Addendum No. 2

New Hanover County Cells 2-6 Partial Closure County Bid No. 15-0212

Issued January 6, 2015

TOE EXCAVATION DETAIL

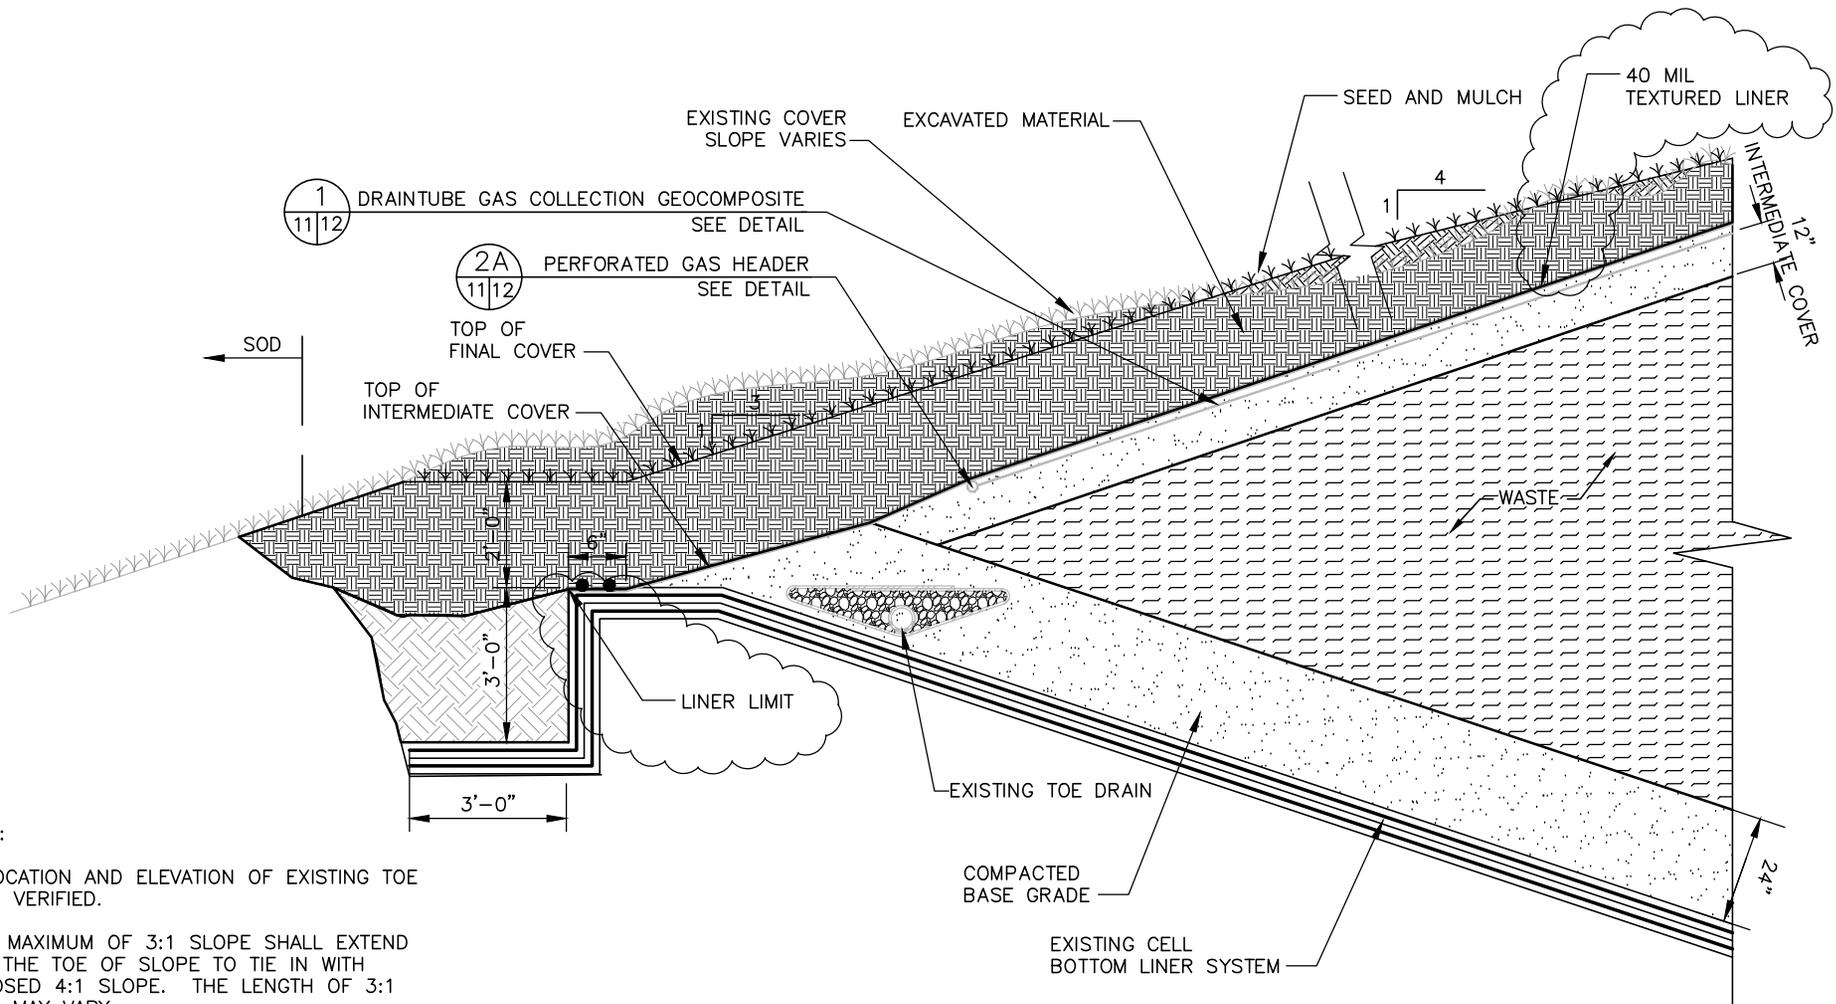
- 5. Dwgs. 4, 5, 6, and 7 have a broken line around the perimeter of the cap area, which indicates the Limits of Liner. Per Dwg. 11, Detail 3, Toe Excavation Detail, please provide a note indicating where these “limits of liner” are in relation to this detail.**

Response: As per Note 6, Drawing 4 of 14, the cap liner is to be welded to the base liner. To clarify for the condition of the referenced detail, the detail has been revised to identify the limits of the liner. Please find the revised Detail enclosed.
